Access Compliance Report

Public Rights-of-Way

Intersection ID: 10025975	Main Street: ELM_LN	Cross Street: N/A	Location: NW
ADA ID: 2B9B99AEE22C	Ramp Type: Perp	Initial Pass/Fail: Pass	Overall Compliance: No
			Severity Score: 10.25

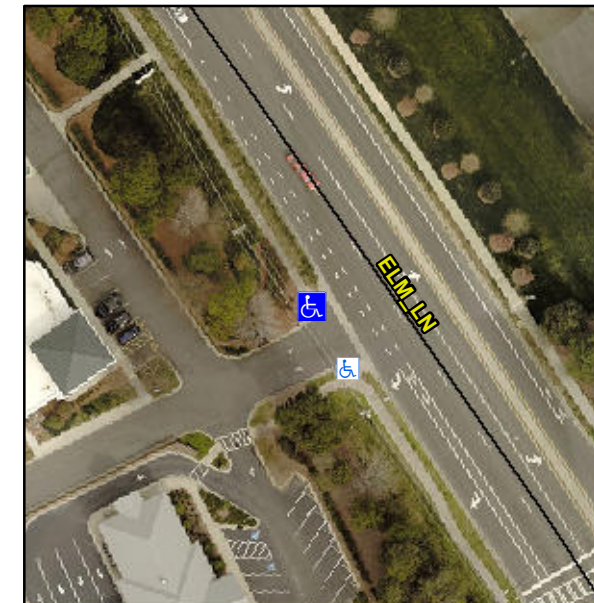
Not Found, R304.5.3, R304.2.1, R304.2.2-Perp, R304.3.2-Para

Compliance	Description	Data	Compliance	Description	Data
N/A	Ramp Length (in)	118.0	Yes	Ramp Slope (%)	5.4
Yes	Ramp Width (in)	48.0	No	Ramp XSlope (%)	2.3
N/A	Flare Type LT	Sloped	N/A	Flare Type RT	N/A
N/A	Flare Slope LT (%)	6.1	Yes	Flare Slope RT (%)	4.3
N/A	Flare Traversable LT?	Yes	N/A	Flare Traversable RT?	Yes
No	Landing Length (in)	N/A	Yes	DWS Provided?	Yes
No	Landing Width (in)	N/A	Yes	DWS Contrast?	Yes
No	Landing Slope (%)	N/A	Yes	DWS Length (in)	24.0
No	Landing X Slope (%)	N/A	Yes	DWS Full Width?	Yes
N/A	Landing Curb? (Y/N)	No	Yes	DWS Offset (in)	1.5
N/A	Shared Landing?	No			
Yes	Gutter Ponding?	No	Yes	Gutter Slope (%)	2.2
Yes	Gutter Lip Ht (in)	0.0	Yes	Gutter X Slope (%)	1.1
N/A	Painted X Walk1?	No	N/A	Painted X Walk2?	N/A
	X Walk 1 Direction	To SE		X Walk 2 Direction	N/A
N/A	X Walk 1 Width (in)	N/A	N/A	X Walk 2 Width (in)	N/A
	X Walk 1 Slope (%)	2.4		X Walk 2 Slope (%)	N/A
	X Walk 1 X Slope (%)	1.4		X Walk 2 X Slope (%)	N/A

Remove & Replace Entire Ramp.
